SEATTLE PACIFIC UNIVERSITY DRAFT MIMP OVERVIEW

DAC Meeting **May 17, 2023**

Open Space Typology Diagram

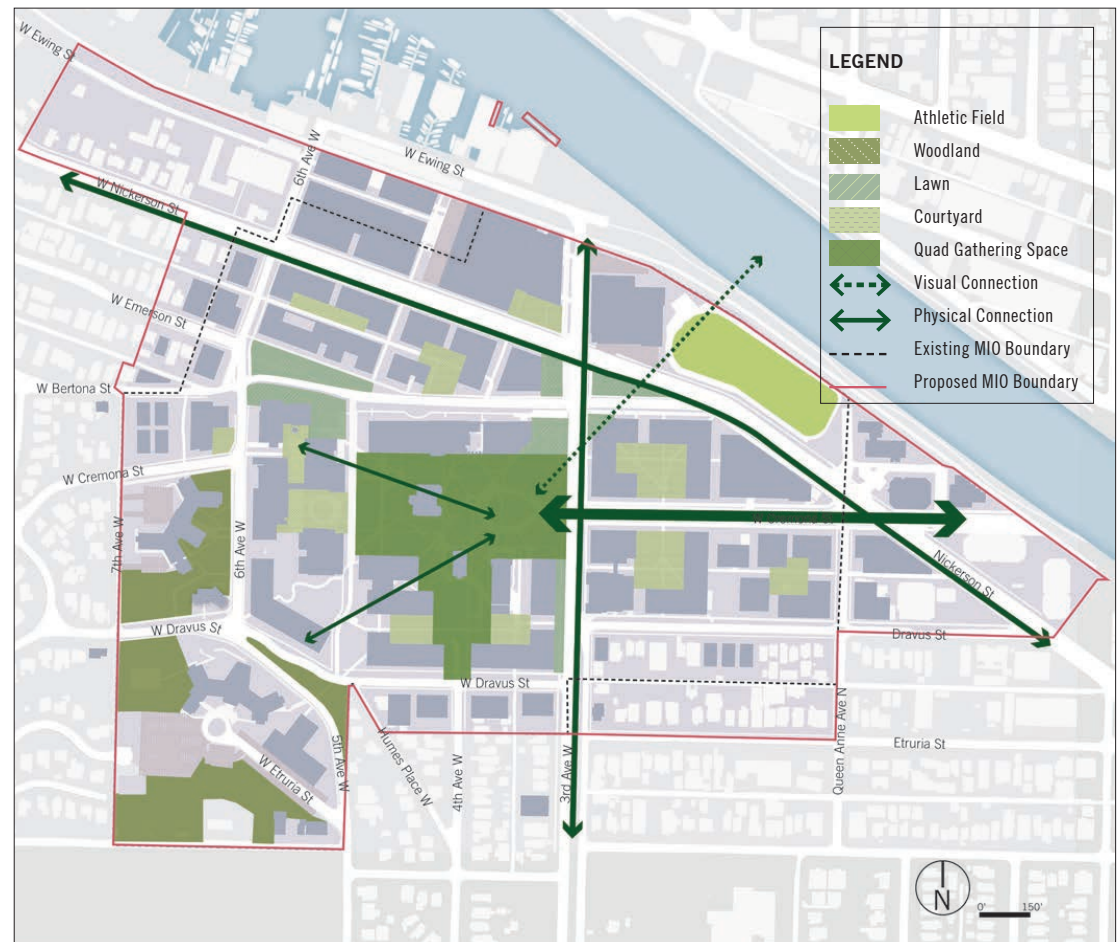
- Need more information about open space typology.

- The open space typology diagram is a visual way to describe the character of different landscapes in and around campus.
- Typologies consider shape, use, context, size, prominence, and relationship to buildings.
- Open space typology is not required, but helps illustrate open space concepts and character, and how the campus sits within the overall open space framework.

Potential new buildings show exact SF.

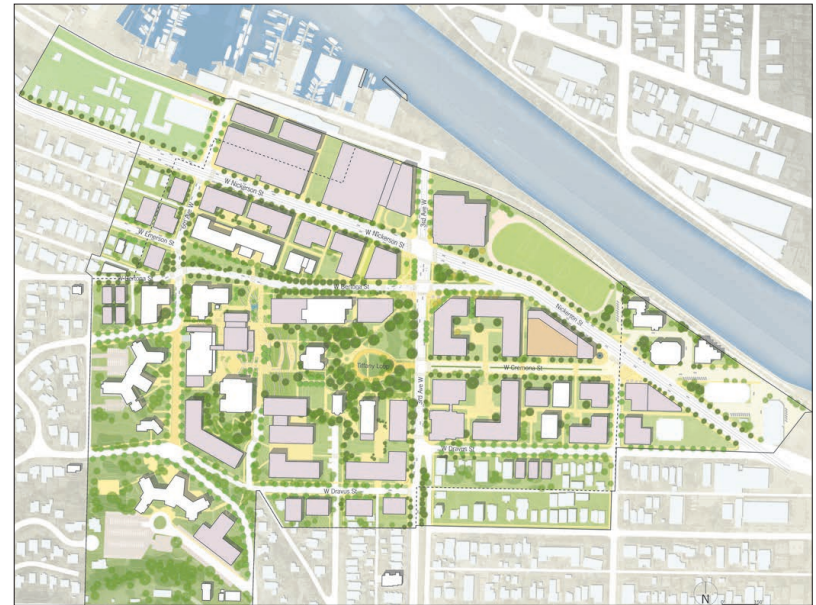
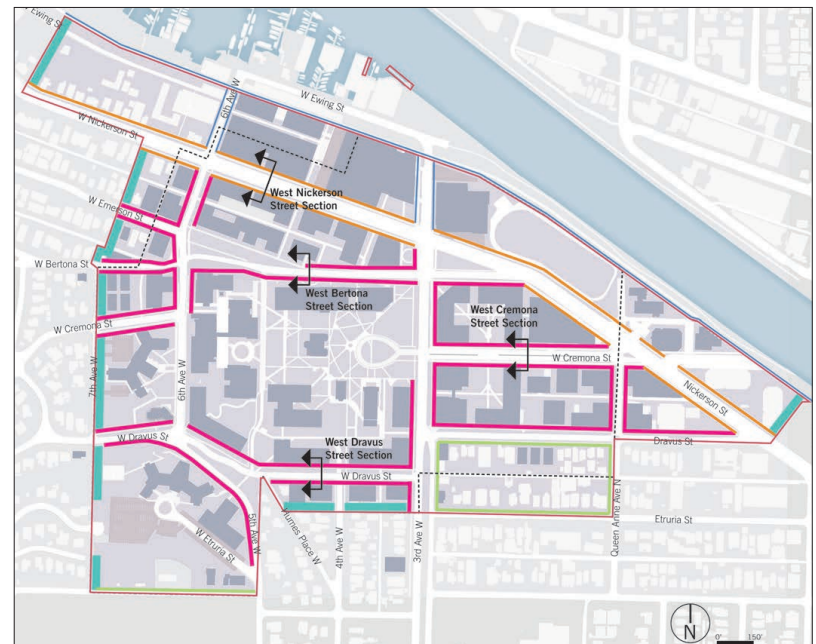
- Distinguish between illustrative maps and maps showing actual square footage (SF).

- Base maps are drawn to scale.
- All potential new development buildings show actual SF.
- All existing buildings, parcels, and zoning districts show approximate SF.*
- Need site survey to have exact SF for existing conditions, which is not an appropriate investment at the planning stage.
- Other diagrams, such as landscape and setbacks, are drawn to illustrate concepts. Marks are proportional and are optimized for readability.

Ashton Hall Site: MIO height limit, parcel delineations, building against hillside.

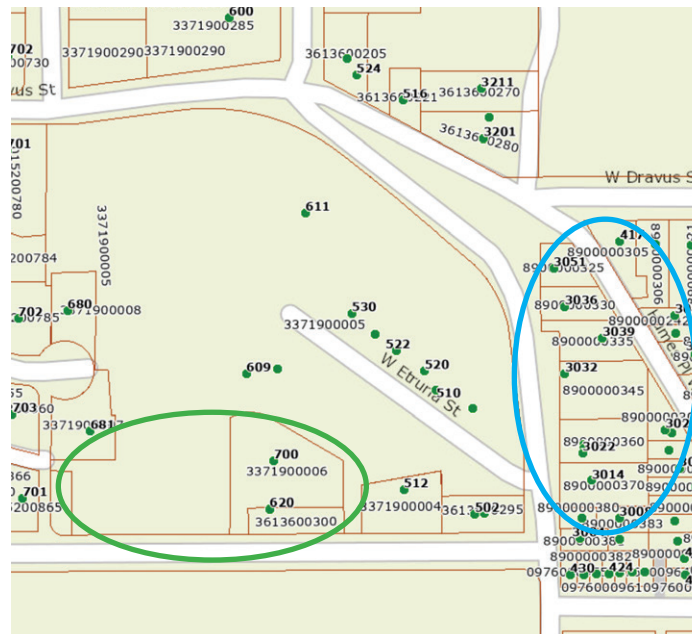
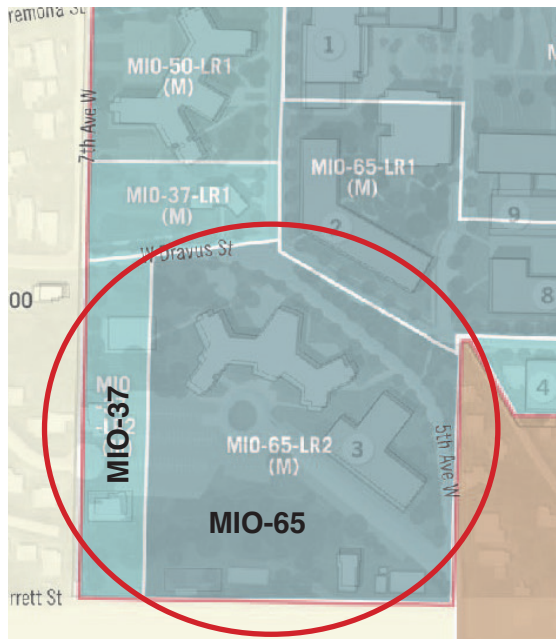
- Can Ashton be a non-conforming use?
- Note the 65-foot designation because Ashton is 57-foot building.
- Concerns about 6-story building on 5th Avenue.
- Concerns about relationship to existing residential.

- 2000 MIMP designates this area at 65 feet.
- This MIMP is not proposing to change this designation.
- Adjacent development is increasing in density.
- Ashton was conforming when built.
- Part of the area was sold for non-SPU development. It will conform to City requirements, not MIMP requirements.
- 6 stories envisioned on "elbow" of 5th Ave W. Vacated Etruria side is lower due to topography.
- 5th: 3 single-family (1 rental), 1 vacant multi-family, 2 triplexes.
